## **INGATE PLACE SUBDIVISION, BLOCK 3,** **RESUBDIVISION OF LOTS 15 & 16**

The preliminary plat illustrates the proposed 1-lot, 0.4± acre subdivision which is located on the East side of Furr Street, 535'± North of Old Shell Road, within Council District 1. The applicant states that the subdivision is served by city water and sanitary sewer systems. The purpose of this application is to create one (1) legal lot of record from two (2) existing legal lots of record.

APPLICATION NUMBER 4 DATE July 15, 2021

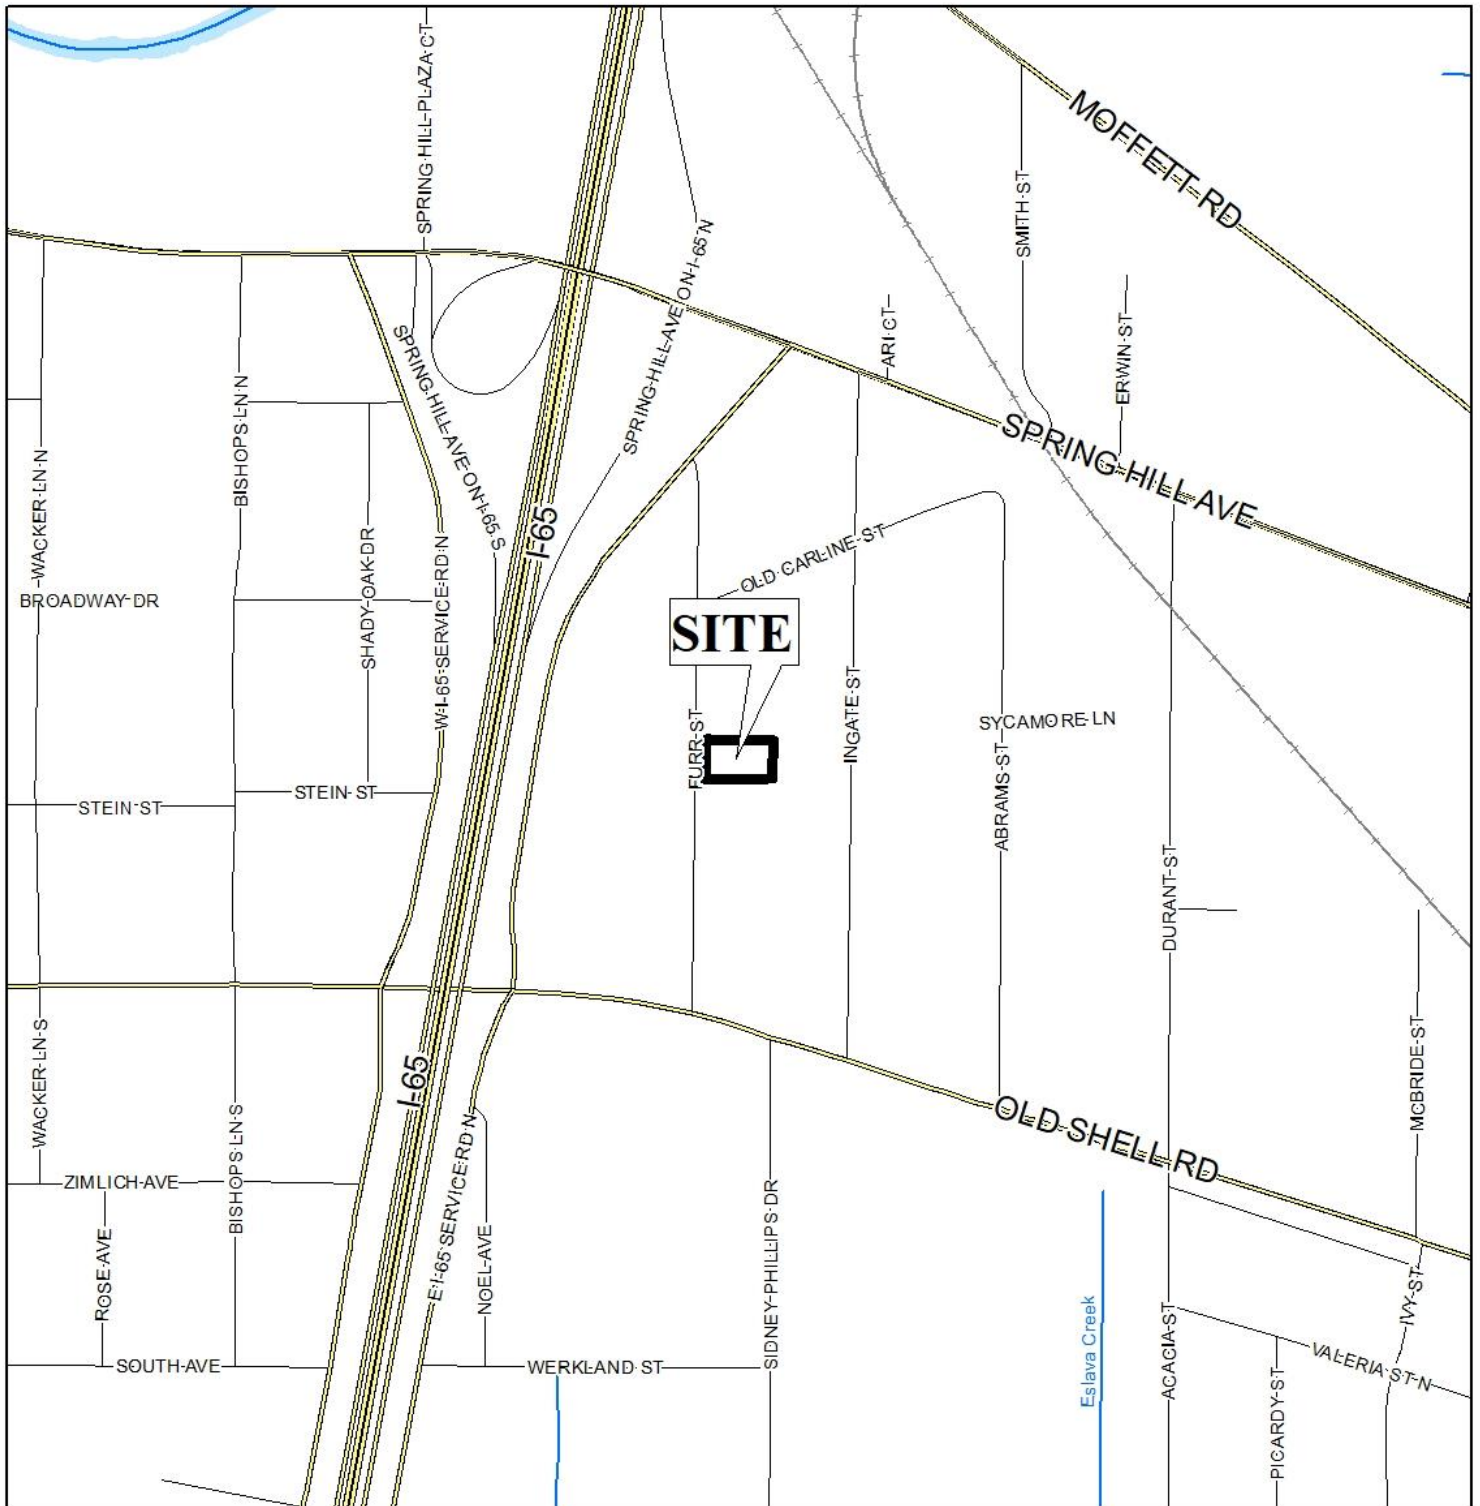
The site has frontage on Furr Street, a minor street with curb and gutter and a compliant 50-foot right-of-way; therefore, no dedication would be required. The right-of-way width of Furr Street should be retained on the Final Plat, if approved. As on the preliminary plat, the 25-foot minimum building setback line should be retained on the Final Plat. The proposed lot meets the minimum size requirements of the Subdivision Regulations. As on the preliminary plat, the lot size label in both square feet and acres should be retained on the Final Plat, or a table should be furnished on the Final Plat providing the same information.

As per the Traffic Engineering comments, the driveway number, size, location, and design are to be approved by Traffic Engineering and conform to AASHTO standards. A note should be required on the Final Plat stating these comments.

Based upon the preceding, the plat meets the minimum requirements of the Subdivision Regulations and is recommended for Tentative Approval, subject to the following conditions:

- 1) retention of the right-of-way width of Furr Street on the Final Plat;
- 2) retention of the 25-foot minimum building setback line on the Final Plat;

- 3) retention of the lot size label in both square feet and acres on the Final Plat, or the furnishing of a table on the Final Plat providing the same information;
